Application for Planning Approval

SA2025/021

6 JIM BACON COURT, BRIGHTON

Request for Information – Subdivision (SA 2025 / 00021)

PLAN OF SUBDIVISION

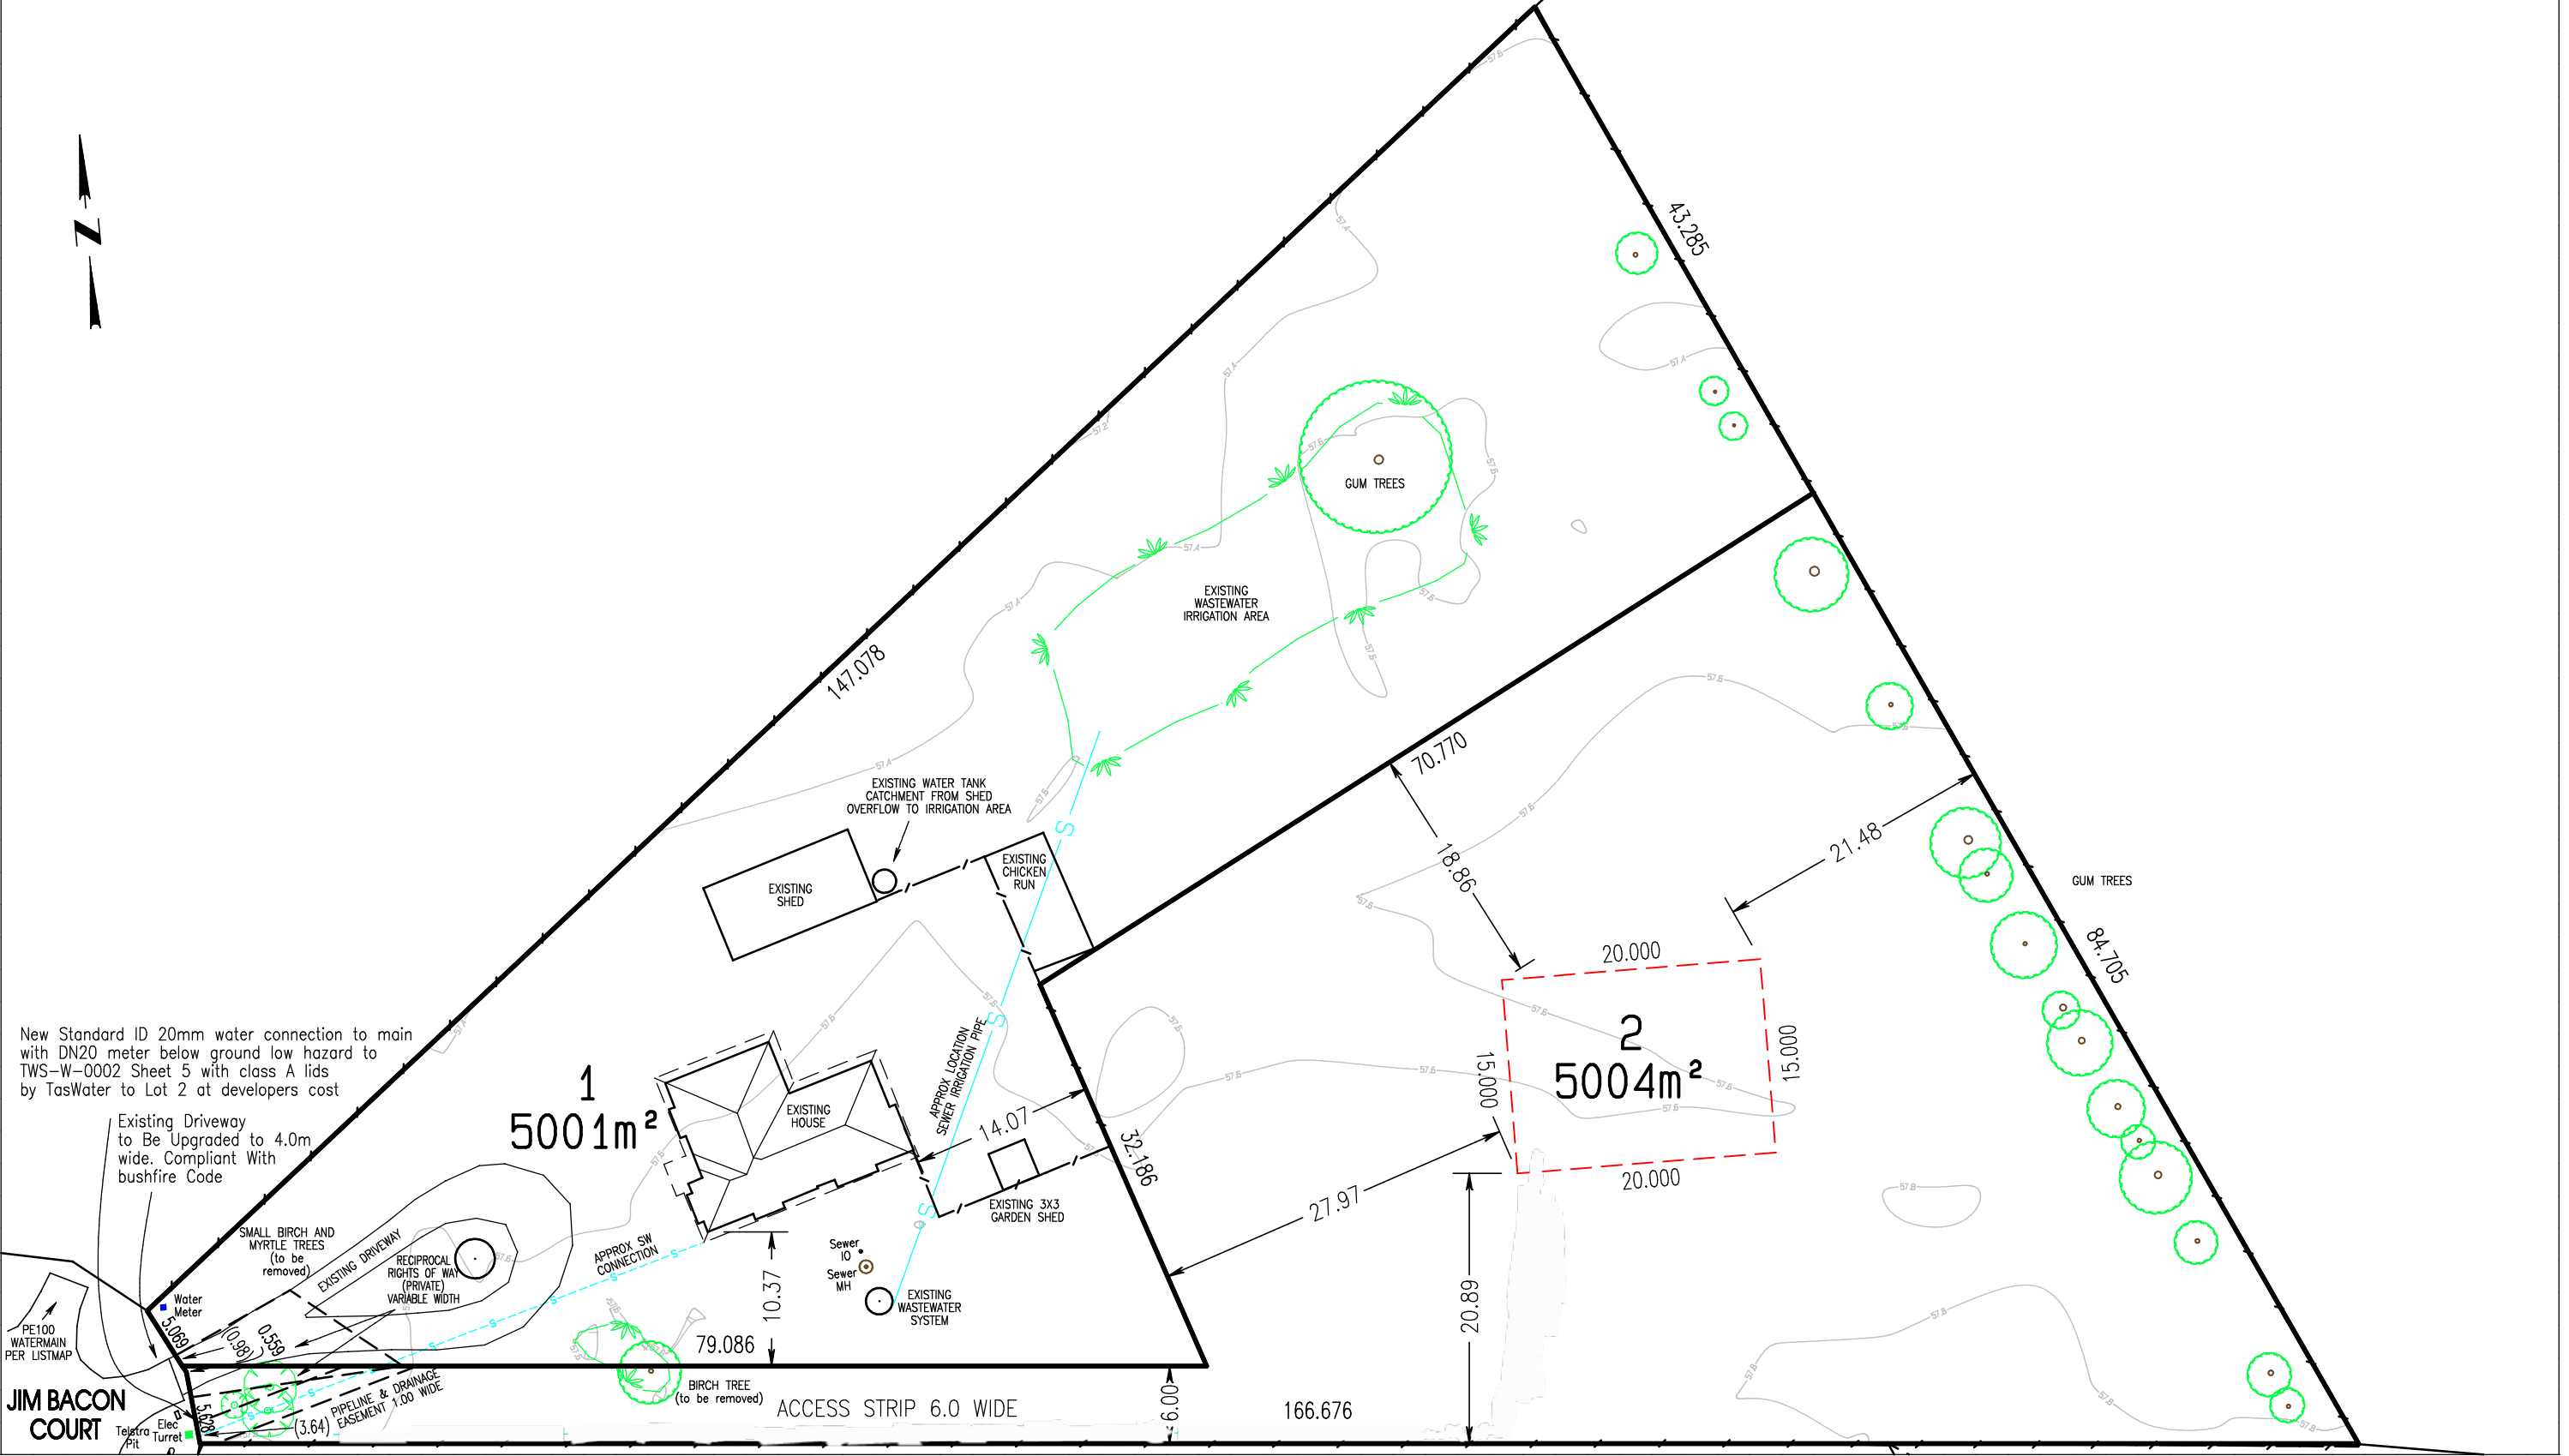
1. Amended proposal plan showing vehicle access compliant with the bushfire code to the boundary of Lot 2, 6 Jim Bacon Court, Brighton. Noting minimum right of way width of 4.0m wide.

Amended proposal plan showing existing stormwater disposal of existing dwelling.
